# Access Compliance Report

## Public Rights-of-Way

Intersection ID: 10038770	Main Street: STEELE_CREEK_RD	Cross Street: N/A	Location: NE
ADA ID: B66BB778C85A	Ramp Type: PerpDiag	Initial Pass/Fail: Fail	Overall Compliance: No
Severity Score: 12.5			
Codes/Mitigation Info/Possible Solution		Field Measurements/Component Compliance

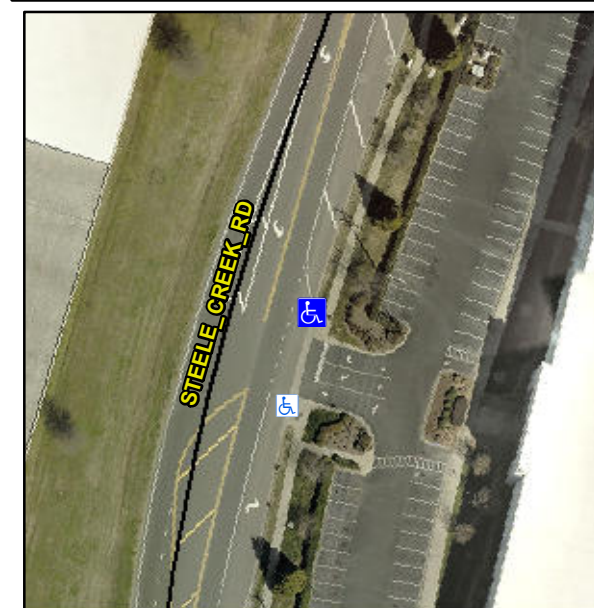
**Not Found, R304.5.3**

Compliance	Description	Data	Compliance	Description	Data
N/A	Ramp Length (in)	59.0	Yes	Ramp Slope (%)	6.6
Yes	Ramp Width (in)	48.0	No	Ramp XSlope (%)	6.0
N/A	Flare Type LT	N/A	N/A	Flare Type RT	N/A
N/A	Flare Slope LT (%)	N/A	N/A	Flare Slope RT (%)	N/A
N/A	Flare Traversable LT?	N/A	N/A	Flare Traversable RT?	N/A
N/A	Landing Length (in)	N/A	N/A	DWS Provided?	N/A
N/A	Landing Width (in)	N/A	N/A	DWS Contrast?	N/A
N/A	Landing Slope (%)	N/A	N/A	DWS Length (in)	N/A
N/A	Landing X Slope (%)	N/A	N/A	DWS Full Width?	N/A
N/A	Landing Curb? (Y/N)	N/A	N/A	DWS Offset (in)	N/A
N/A	Shared Landing?	N/A			
N/A	Gutter Ponding?	N/A	N/A	Gutter Slope (%)	N/A
N/A	Gutter Lip Ht (in)	N/A	N/A	Gutter X Slope (%)	N/A
N/A	Painted X Walk1?	No	N/A	Painted X Walk2?	No
	X Walk 1 Direction	To W		X Walk 2 Direction	To S
N/A	X Walk 1 Width (in)	N/A	N/A	X Walk 2 Width (in)	N/A
	X Walk 1 Slope (%)	3.4		X Walk 2 Slope (%)	0.8
	X Walk 1 X Slope (%)	1.1		X Walk 2 X Slope (%)	1.7

**Remove & Replace Curb Ramp With Two New Directional Ramps or Equivalent.**
